# Access Compliance Report

## Public Rights-of-Way

Intersection ID: 7316	Main Street: SILCHESTER_LN	Cross Street: SWINDON_CT	Location:	N
ADA ID: 8C0ED5ADC9C5	Ramp Type: Para	Initial Pass/Fail: Fail	Overall Compliance: No	Severity Score: 17.5

#### Codes/Mitigation Info/Possible Solution

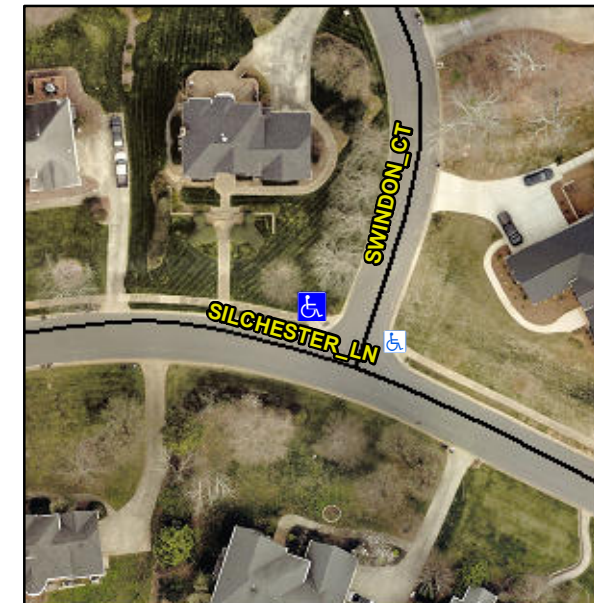
**LT RP < 5%, RT RP < 5%**

**R304.5.1**

Compliance	Description	Data	Compliance	Description	Data
N/A	Ramp Length LT (in)	56.0	N/A	Ramp Length RT (in)	56.0
No	Ramp Width LT (in)	47.0	No	Ramp Width RT (in)	34.0
Yes	Ramp Slope LT (%)	3.4	Yes	Ramp Slope RT (%)	2.3
Yes	Ramp XSlope LT (%)	0.9	Yes	Ramp XSlope RT (%)	1.3
N/A	Landing Length (in)	N/A	N/A	DWS Provided?	N/A
N/A	Landing Width (in)	N/A	N/A	DWS Contrast?	N/A
N/A	Landing Slope (%)	N/A	N/A	DWS Length (in)	N/A
N/A	Landing X Slope (%)	N/A	N/A	DWS Full Width?	N/A
N/A	Landing Curb? (Y/N)	N/A	N/A	DWS Offset (in)	N/A
N/A	Shared Landing?	N/A			
N/A	Gutter Ponding?	N/A	N/A	Gutter Slope (%)	N/A
N/A	Gutter Lip Ht (in)	N/A	N/A	Gutter X Slope (%)	N/A
N/A	Painted X Walk1?	No	N/A	Painted X Walk2?	N/A
	X Walk 1 Direction	To SE		X Walk 2 Direction	N/A
N/A	X Walk 1 Width (in)	N/A	N/A	X Walk 2 Width (in)	N/A
	X Walk 1 Slope (%)	2.7		X Walk 2 Slope (%)	N/A
	X Walk 1 X Slope (%)	5.3		X Walk 2 X Slope (%)	N/A
N/A	Ramp inside XWalk1?	N/A	N/A	Ramp inside XWalk2?	N/A

**Remove & Replace Entire Ramp.**
